No. 307

I.C.C Schlage cylinder Improvement

PRODUCT UPDATE

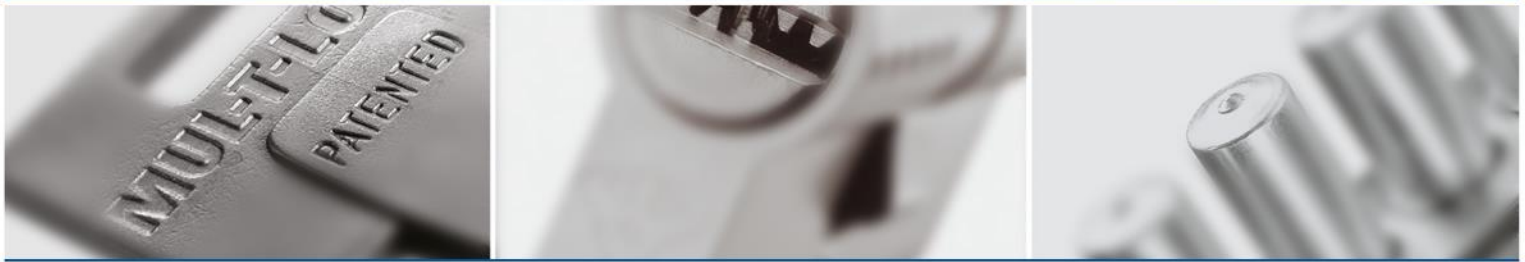
we are happy to share with you an improvement that we have done to the I.C.C Schlage MTL400 & MTL600 Cylinders.

The new configuration is identical to the configuration of the MT5/MTL800 cylinders which has been proven for several years.

In most of the applications no tail is needed but if you need one, use tail as shown below:

This new configuration is also allowing the use of the OEM tails that may be already supplied with the locks.

When you order those cylinders in parts (not assembled) the plug is only the different part.
